**NEBRASKA ARMY NATIONAL GUARD  
SEWARD MUSEUM CLIMATE CONTROLLED STORAGE**

PROJECT NO. 31030117

**A D D E N D U M   N O .   1**

**A4.1**

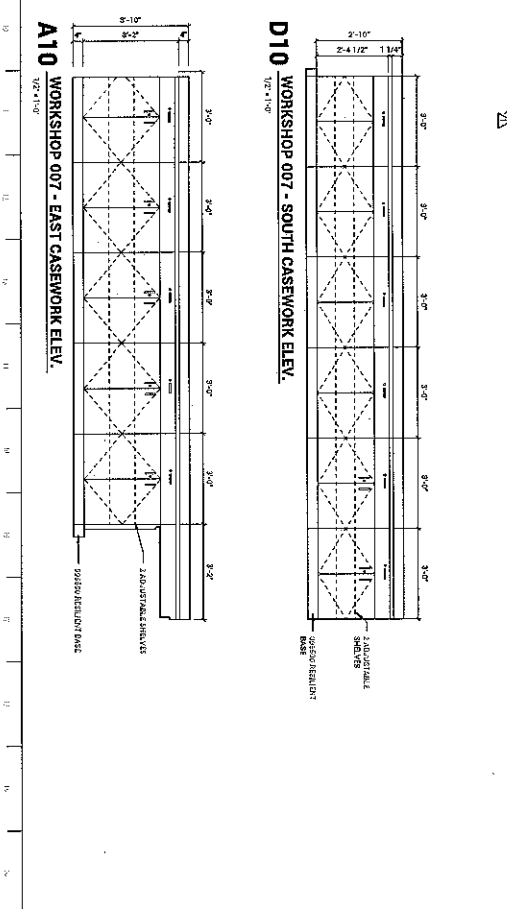
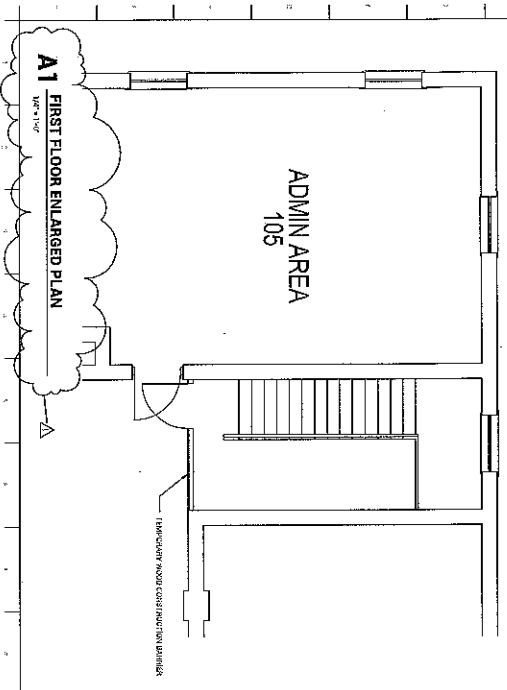
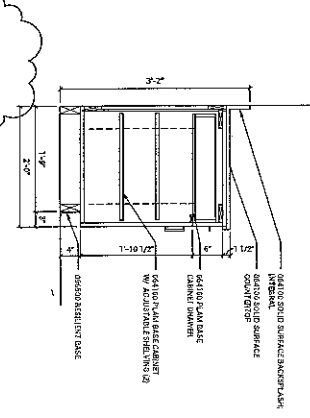
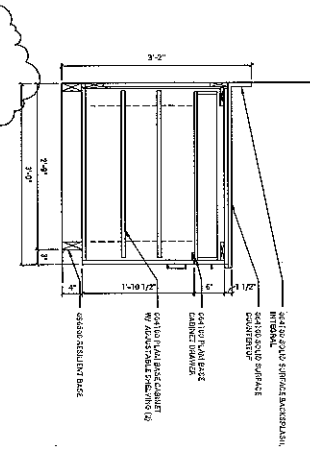
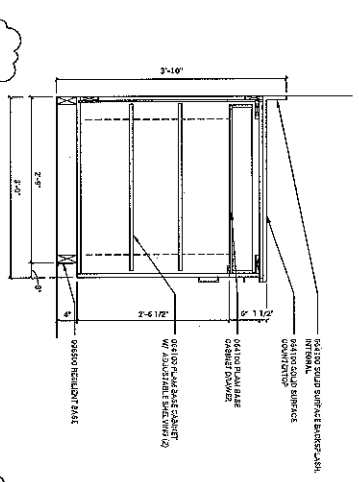
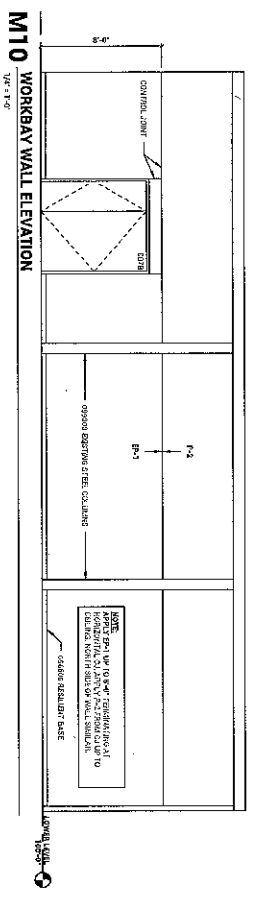
ADD 1-4     Contractor shall construct temporary construction barrier as indicated on detail A1 sheet A4.1. Wall shall be 2 x 4 wood studs with 5/8 inch plywood on the Assembly Hall side of the

wall. Provide 3 foot wide by 7 foot high door with hinges, passage lockset and a hasp for a padlock. Padlock will be supplied by the Owner.
